Queenstown Control Zone

Joint Petition for Amendment

Volume 1 Version 3.0

31 October 2025

Figure 2 Queenstown CTR VNC Chart (old and new boundary)

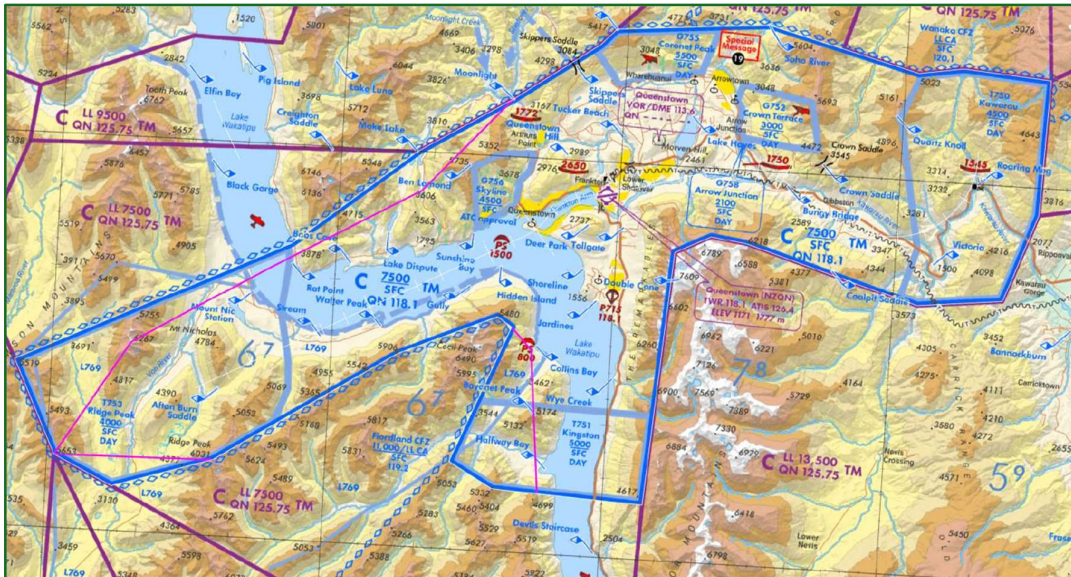
The following amended CTR Queenstown Control Zone (QN CTR/C) A756 SFC/7500ft is proposed, balancing the benefit of releasing controlled airspace whilst maintaining an easily navigable and predictable CTR boundary.

The two images below depict the current CTR boundary (solid blue) and the proposed boundary (magenta).

West from Moonlight VRP, the CTR boundary draws inward by roughly 1.5 NM in the vicinity of Moke Lake, an area regularly used by helicopter operators.

Westward, the area over Lake Wakatipu between Rat Point VRP and Mt Nic Station VRP is heavily utilised by traffic departing to and returning from Milford.

In the remaining areas, north and west of Afton Burn VRP, relatively little traffic enters, exits or operates within the zone. Providing an ATC service in these portions of airspace is not required.

Figure 7 Proposed T750 Kawarau 4500 Transit Lane

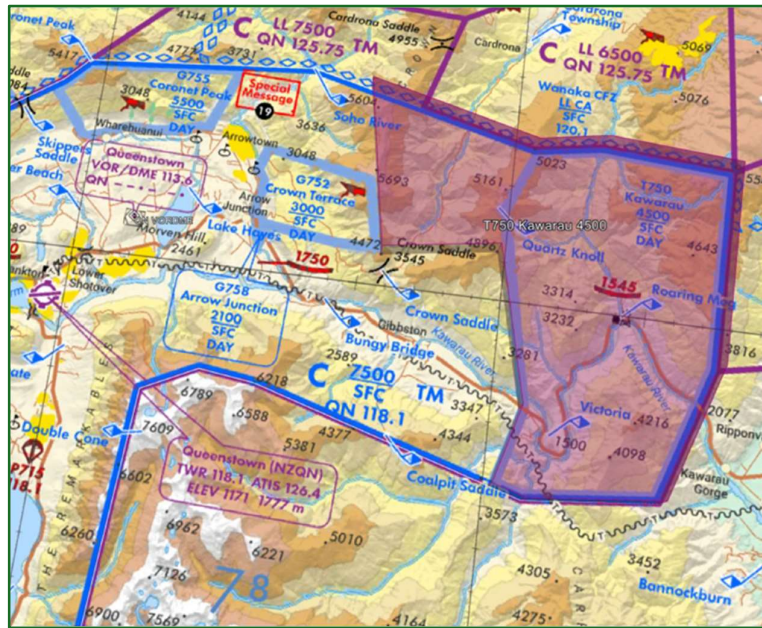
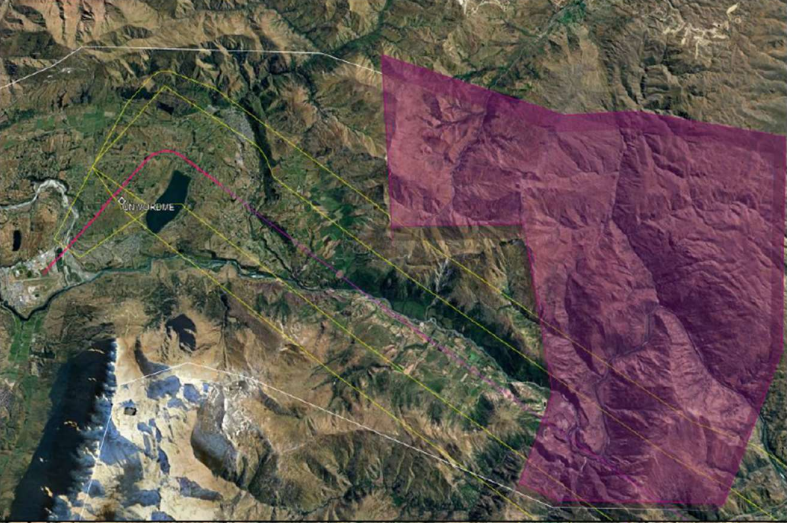
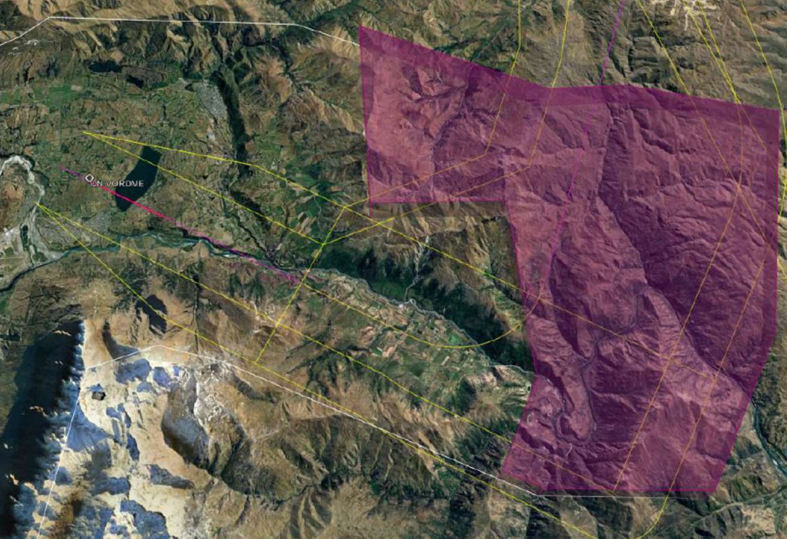
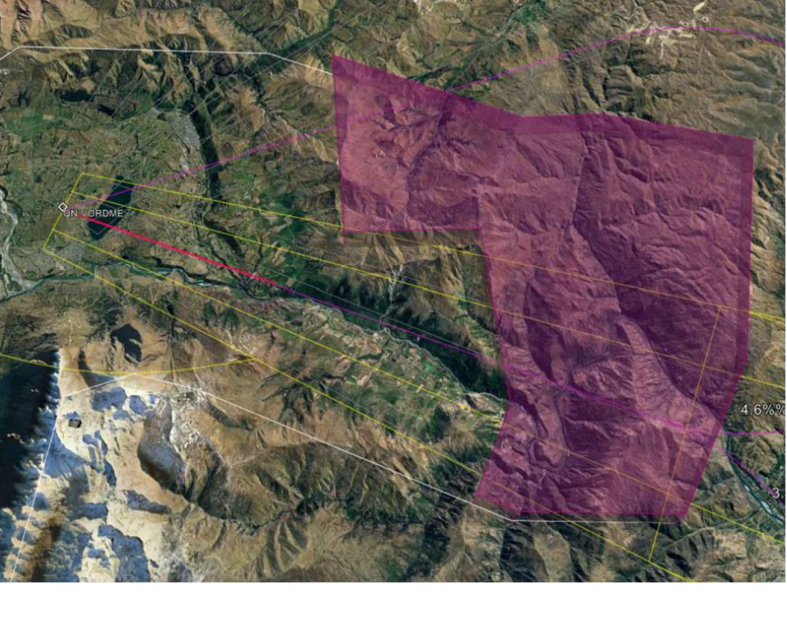
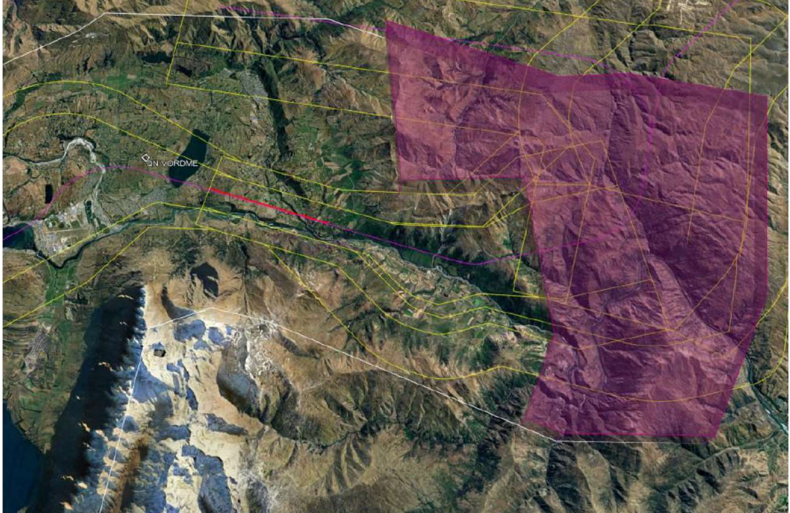
Expand the current T750 Transit Lane further west along the northern boundary of the CTR.

<p>i. RNP Y and Z RWY 23</p> <p>Lateral separation of RNPx2 + 1NM to QN760 (not below 5100ft)</p> <p>Vertical separation (500ft) beyond QN760 (including 1NM buffer, no change)</p>
--	--

<p>ii. SID BIXAL 2R</p> <p>Cross QN736 at or above 1750ft, 3250ft to reach separation level above T750.</p> <p>5.7NM of climb on nominal track at minimum procedure gradient of 9.3% (570ft/NM) to reach 5000ft.</p> <p>Laterally separated from primary and secondary protection areas below 5000ft then vertically separated by greater than 500ft including 1NM buffer.</p>
	<p>iii. SID GIXEL3</p> <p>Cross QN VOR at or above 4300ft, 700ft to reach separation level above T750.</p> <p>2.0NM of climb on nominal track at minimum procedure gradient of 5.8% (350ft/NM) to reach 5000ft.</p> <p>Laterally separated from primary and secondary protection areas below 5000ft then vertically separated by greater than 500ft including 1NM buffer.</p>
	<p>iv. SID Bridge</p> <p>Cross QN VOR either at or above 3600ft with a 4.6% (280ft/NM) climb requirement, or 4100ft with a 3.3% (200ft/NM) climb requirement.</p> <p>5NM of climb on nominal track at minimum procedure gradient of 4.6% to reach 5000ft or 4.5NM of climb on nominal track at minimum procedure gradient of 3.3% to reach 5000ft.</p> <p>Laterally separated from nominal track + 2NM to 5000ft then vertically separated by greater than</p>

<p>500ft.</p> <p>v. RNP045</p> <p>MDA 2530ft, 8.7% (530ft/NM) climb gradient to 3200ft, then default 5% MA airspace containment gradient.</p> <p>7.64NM of climb required to reach 5000ft.</p> <p>Laterally separated from primary and secondary protection areas below 5000ft then vertically separated by greater than 500ft including 1NM buffer.</p>
	<p>vi. RNP 330</p> <p>MDA 2350ft, 5.6% (350ft/NM) climb gradient to 4500ft, then default 5% MA airspace containment gradient 4.9NM of climb required to reach 5000ft.</p> <p>Laterally separated from nominal track + 2NM to 5000ft then vertically separated by greater than 500ft including 1NM buffer.</p>
	<p>vii. RNP G and RNP H</p> <p>MDA 4100ft at QN603. 3NM at an approach gradient of 300ft/NM to be above 5000ft.</p> <p>Laterally separated from primary and secondary areas to 5000ft then vertically separated by greater than 500ft including 1NM buffer.</p>

Figure 8 Proposed T751 Kingston 5000 Transit Lane

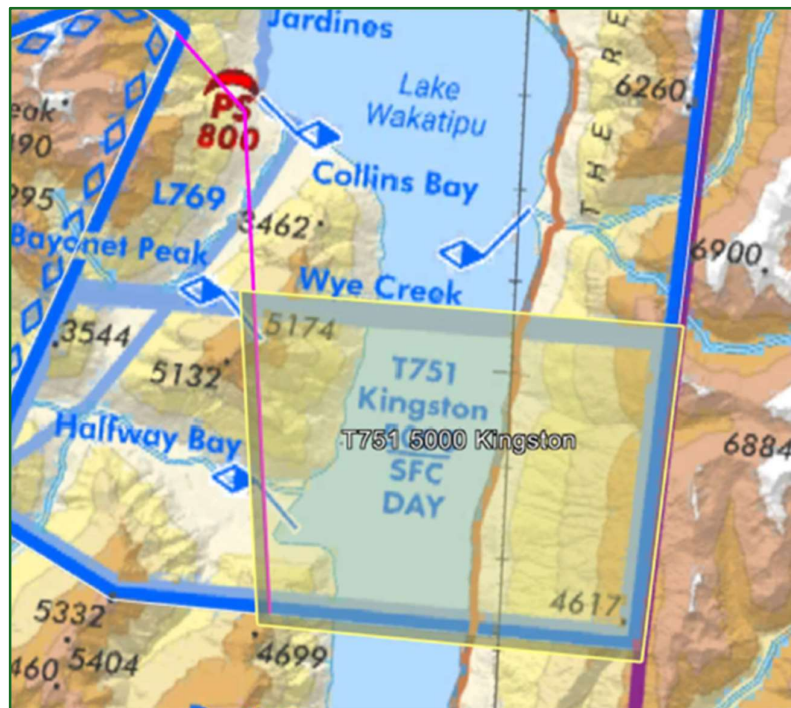
Reduce the size of T751 by moving the western and southern boundaries resulting from the CTR boundary change.

Separation Assessment: the Transit Lane has been altered on its western and southern boundaries due to the CTR dimensional change. The northern boundary, and height of the TZ, which both affect its separation from relevant IFPs remain unchanged. There is no change to the separations already established between T751 Kingston and relevant IFPs.

Figure 9 Proposed T753 Ridge Peak 4000 Transit Lane

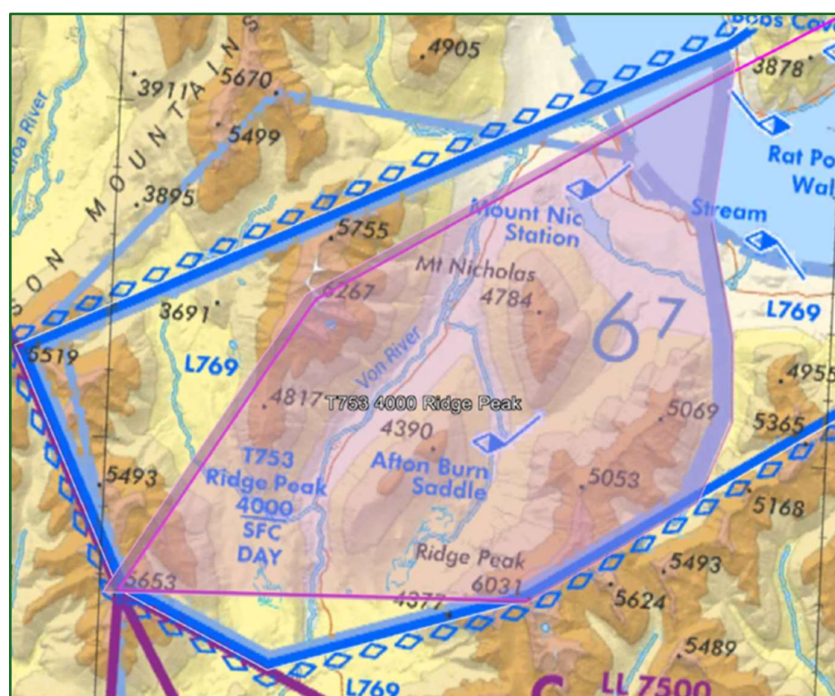
Reduce the size of T753 by amending the northern, western and southern boundaries as a result of CTR boundary changes.

Separation Assessment: the Transit Lane has been altered on its northern, western and southern boundaries due to the CTR dimensional change. The eastern boundary, and height of the TZ, which both affect its separation from relevant IFPs remain unchanged. There is no change to the separations already established between T753 Ridge Peak and relevant IFPs.

Figure 10 Proposed Gibbston Transit Lane - SFC/2,700ft

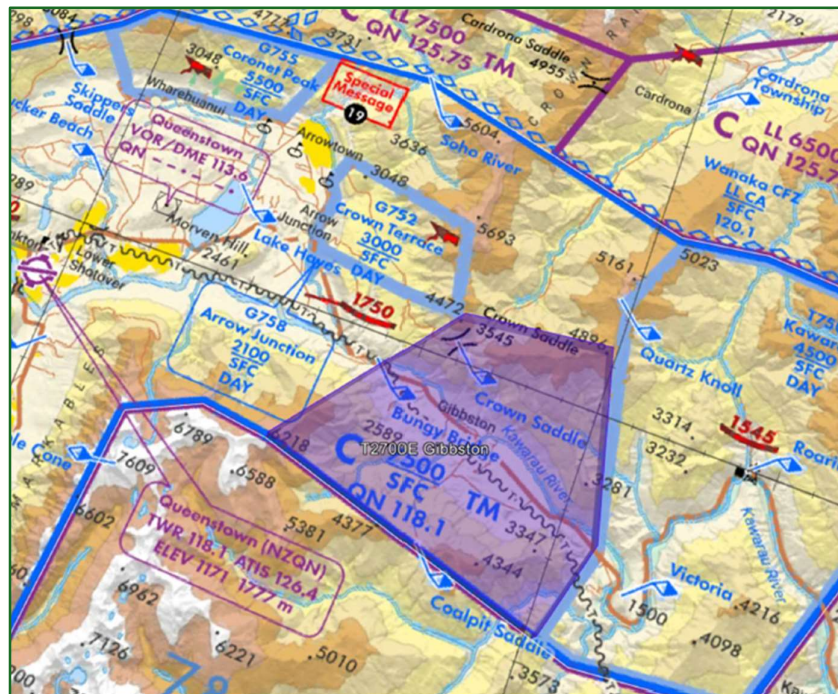
<p>i. RNP Y & Z RWY23.</p> <p>At or above 3300ft at LARAV (FAF). Vertical separation point versus proposed T2700E is 0.3NM closer to QN at the procedure approach angle of 3.2°.</p> <p>At the boundary of the transit lane the Gibbston Valley narrows significantly. Ben Cruachans, 6217 ft defines the boundary to the south, the Bungy Bridge VRP in the centre of the valley, and the 4472ft feature just Northwest of the Crown Saddle to the north.</p> <p>Such strong predominant geographical features will allow a reduction in the standard 1NM buffer from the vertical separation point. Buffer will be reduced to 0.5NM on the nominal track to 0.35NM at the limit of the lateral protection area.</p>
	<p>ii. SID DOVMA4</p> <p>Laterally separated outside of the protection area.</p>
	<p>iii. SID IPNOR6</p> <p>Laterally separated outside of the protection area.</p>

<p>iv. SID ANPOV5</p> <p>Laterally separated outside of the protection area.</p>
	<p>v. BIXAL2</p> <p>Cross QN736 (IDF) at or above 1750ft, 1450ft to reach separation level above proposed T2700E at 570ft/NM requiring 2.6NM. Vertical separation includes 1NM buffer</p>
	<p>vi. RNP045</p> <p>MDA 1850ft, 1350ft to reach separation level above proposed T2700E at 8.7% (530ft/NM) procedure required gradient, requiring 2.55NM.</p>

Figure 11 Proposed Remarkables Transit Lane - SFC/3,500ft

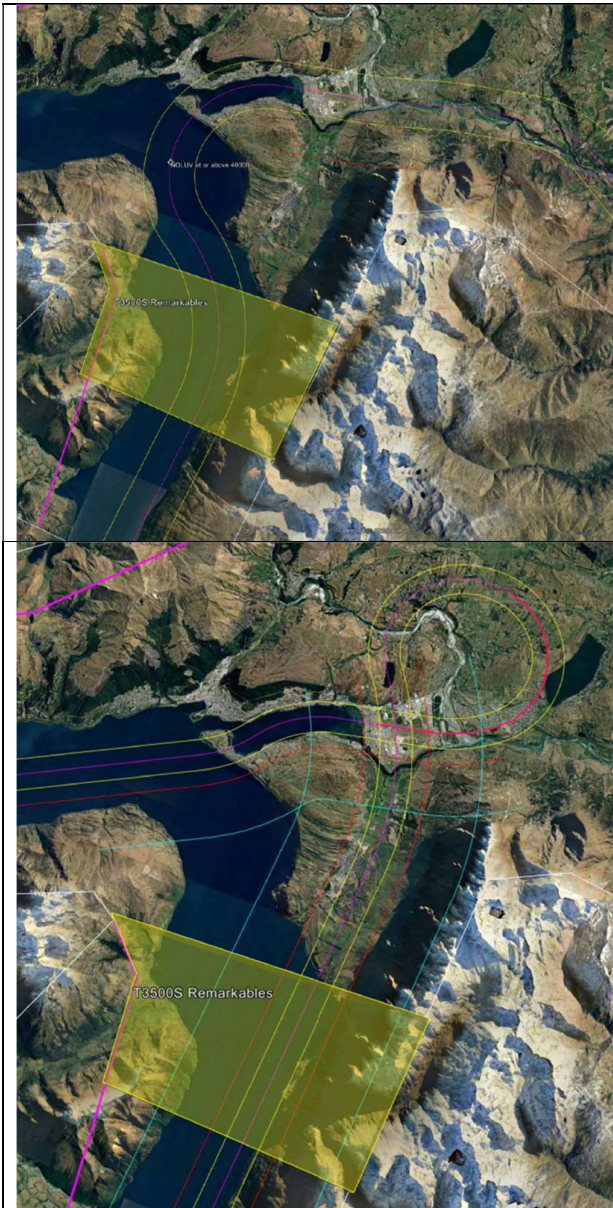
Note: Cat H approach RNP330 and Cat H departure UNSEG1 are not separated from T3500S. These procedures are also not separated from the current T751 Kingston. The procedures are designed to enter from or exit to uncontrolled airspace and these changes are acceptable to HeliOtago (the user).

Protection from at or above 4000ft at NOLUV.

Approach MDA 2324ft, 1676ft required to climb above proposed T3500S at a default MA airspace containment gradient of 5% (300ft/nm) requiring 5.6NM.

Figure 12 Proposed Walter Peak Transit Lane – SFC/2,700ft

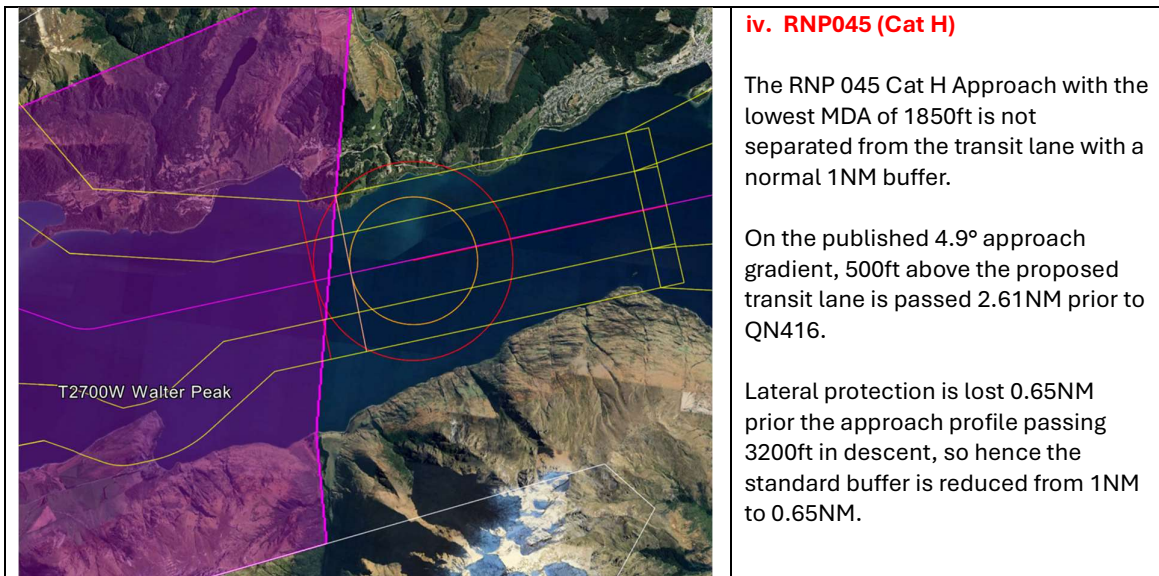
Note: this version of the proposed T2700W Walter Peak TZ differs from the previous petition version. The eastern boundary has been shifted further west following further consultation with operators. The buffer from IFPs has increased.

The controlling Instrument Flight Procedures for the proposed Walter Peak Transit Lane are the RNP Y and Z approach for RWY05, the RNP Y and Z RWY23 Missed Approaches, the RNP045 approach and the BOTNI1 SID.

<p>i. RNP Y & Z RWY23 Missed Approach</p> <p>Laterally separated from the lateral protection areas of RNPx2 + 1 NM.</p>
	<p>ii. RNP Y & Z RWY05</p> <p>OMUBO (FAF) is at or above 3100ft, at the published 3.2° approach gradient the approach profile with descend within 500ft of the proposed transit lane 0.3NM prior to OMUBO.</p> <p>With a standard buffer of 1NM, full lateral protection is provided until clear of the transit lane. (This is an improvement on the previously proposed TZ which required a reduced buffer)</p>
	<p>iii. BOTNI1 Departure</p> <p>Requires cross of QN537 (IDF) at or above 2250ft. 950ft of climb required to reach 500ft above proposed transit lane.</p> <p>Required SID climb gradient after QN537 is 520ft/NM, 1.83NM required to reach 3200ft.</p> <p>With a standard 1NM buffer, full lateral protection is provided until the SID has climb clear of the transit lane.</p>

Figure 13 Proposed new frequency assignment and CFZ boundary

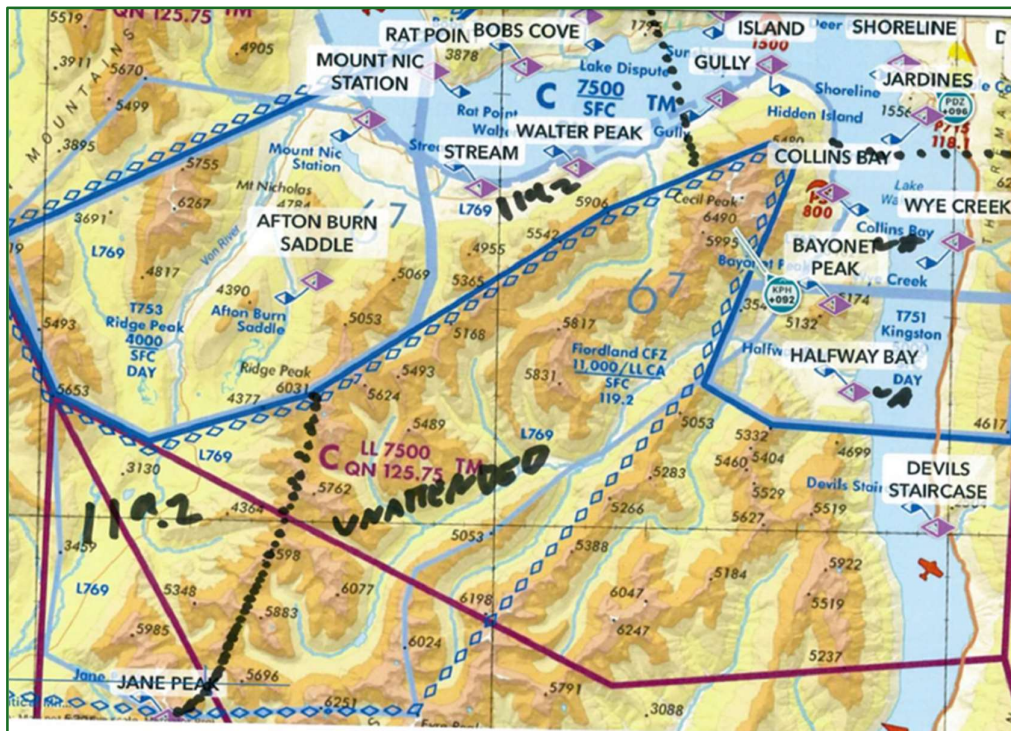
- Walter Peak TZ and Ridge Peak TZ – 119.20 MHz (Fiordland CFZ)
Assign Fiordland CFZ 119.20 to Ridge Peak and Walter Peak TZs
- Modify the Fiordland CFZ boundary, that the eastern boundary on the south side of the CTR would be defined as Ridge Peak, following the range of mountains to Jane Peak to exclude activity on the eastern side of this mountain range from the CFZ.

Utilising the existing, adjacent, CFZ frequency in the Ridge Peak and Walter Peak Transit Lanes will ensure traffic that is operating within proximity and have potential to interact with each other are communicating on the same frequency.

Increased radio traffic on the Fiordland CFZ is partially mitigated by adjusting the CFZ boundary to exclude the area east of the ridgeline between Ridge Peak and Jane Peak. Aircraft activity in this area is generally of a different nature and is geographically differentiated from other Fiordland CFZ traffic by the mountain range.

Figure 14 proposed new VRPs

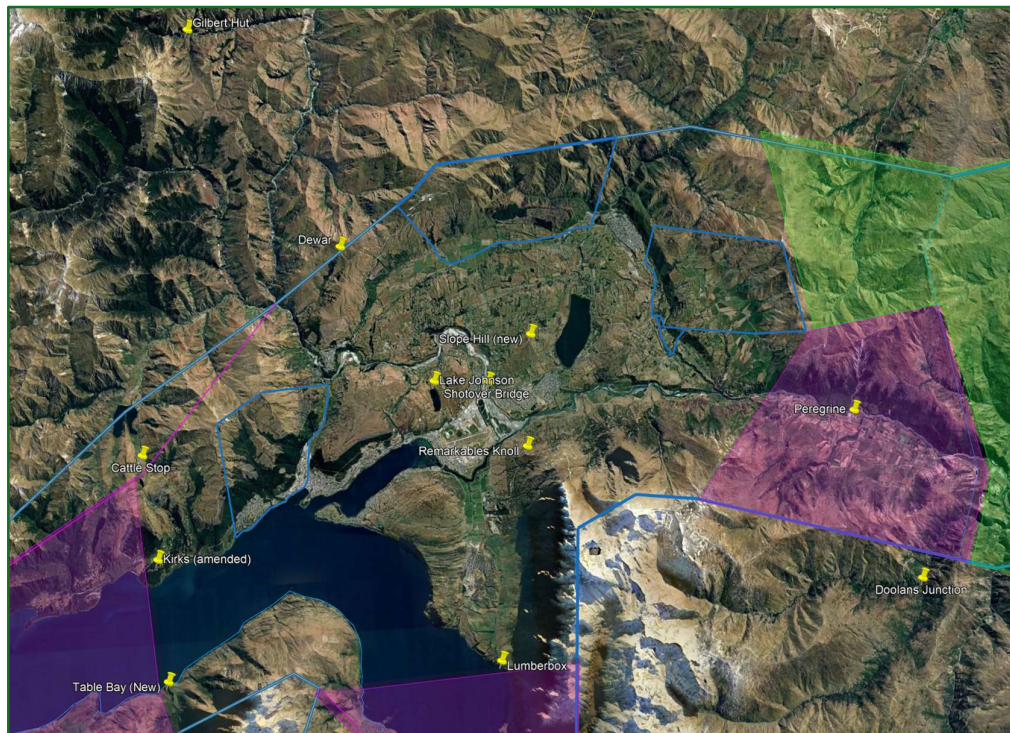
Note: Kirks VRP has been slightly re-located and two new VRPs included since the previous version of the petition.

- 1) **Kirks** - **45°03'33.40"S 168°34'41.40"E** 1795ft feature
Primarily identifies the eastern boundaries of the Walter Peak TZ. Secondly assists with application of geographic separation using the West Sector which ends roughly 1200m to the east of the VRP. This VRP has been amended to better align with the amended Walter Peak TZ.

- 4) **Peregrine** - **45°01'12"S 168°57'03"E** Peregrine vineyard main building
Peregrine VRP will replace Gibbston VRP as a more definitively recognisable landmark and will become the final VRP in the Gibbston Arrival procedure ("hold east of Gibbston will become "hold east of Peregrine"). Gibbston, once a small settlement, has been developed and grown. It has become a less definitive location and now creates confusion for pilots. Peregrine vineyard is a visually distinct building next to the main road, and an easily recognisable specific feature.

- 12) **Slope Hill** - 44°59'20.80"S 168°46'57.50"E Slope Hill summit and QN VOR/DME
Slope Hill is a well-known geographical feature that is commonly used today for holding VFR traffic as well as helping to identify the vicinity of the aerodrome. In the future, it will be used more often, including within new procedures associated with the development of the Northern Helicopter Apron

- 13) **Table Bay** - 45°06'18.40"S 168°34'46.20"E Table Bay (McKinlays Creek mouth)
This prominent geographical feature will assist with identifying the eastern boundary of the Walter Peak TZ.

Figure 15 VRPs proposed to be deleted

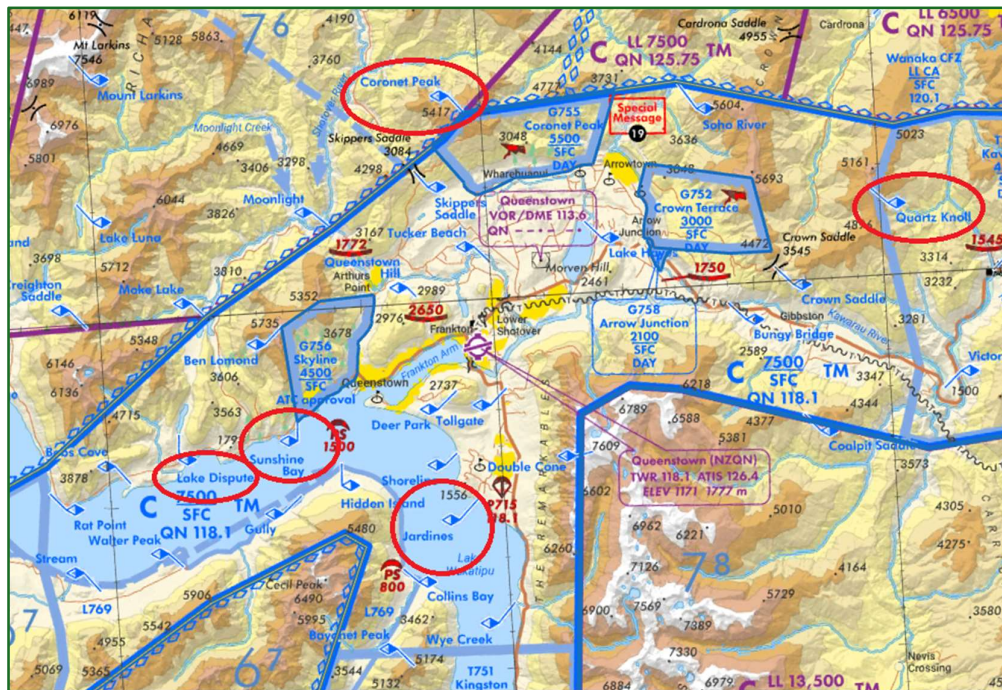
Note: The previous version of the petition sought to remove Sunshine Bay VRP. Sunshine Bay VRP is now retained, as it remains an important reference when flying the figure-8 circuit.

- ▶ Quartz Knoll – is rarely used and not required (related to old Class D procedures)
- ▶ Lake Dispute – is rarely used and not required (related to old Class D procedures)
- ▶ Coronet Peak – an outcome of the IBPS workshops is a change to VFR/GA traffic handling techniques within the QN CTR/C. The group will stop using the area behind and around Coronet Peak to enter and exit the QN CTR/C as it generates crossing flight tracks and interferes with NZG755.
- ▶ Jardines – Jardines VRP - indicates the old runway strip that is no longer in use. It can be removed. A new VRP should be established further south near Drift Bay: Lumberbox VRP, to better serve as a holding point before reaching Jardines PDS.
